Technical Apparels (Pvt.) Limited.

Plot 01, Sector 7, CEPZ, Chattogram

15 April 2025

2. Observations

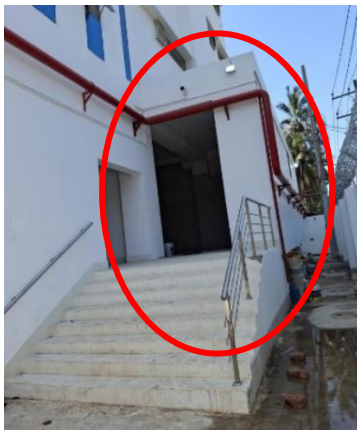
Observation-1: Lack of design documents and load plan (Factory Building)

Description: As per BNBC, every building or structure designed shall have its design documents prepared under the provisions of Section 1.9. The design document shall include a design report and a set of structural drawings, which shall be prepared in compliance with section 1.9.2 and section 1.9.3 as per BNBC 2020.

At the time of inspection, the design report, floor load plan & sufficient material test report were not available. Building engineer is required to prepare a set of design documents, including design report, as-built drawings and a floor load plan in compliance with BNBC based on in-situ material strength.

Item No.	Observation	Action Plan	Timeline
1.	Lack of design documents and load plan (Factory Building)	Verify in-situ material strength for concrete by taking 100 mm diameter minimum 4 nos. from columns and 4 nos. from beam/slab.	within 6 weeks

2.		Produce floor live load plan for all floor plates following BNBC requirements and based on column & foundation capacity.	within 6 weeks
3.		The building engineer is required to prepare a set of design documents in compliance with BNBC 2020 based on the floor load plan and in-situ material strength.	within 6 weeks
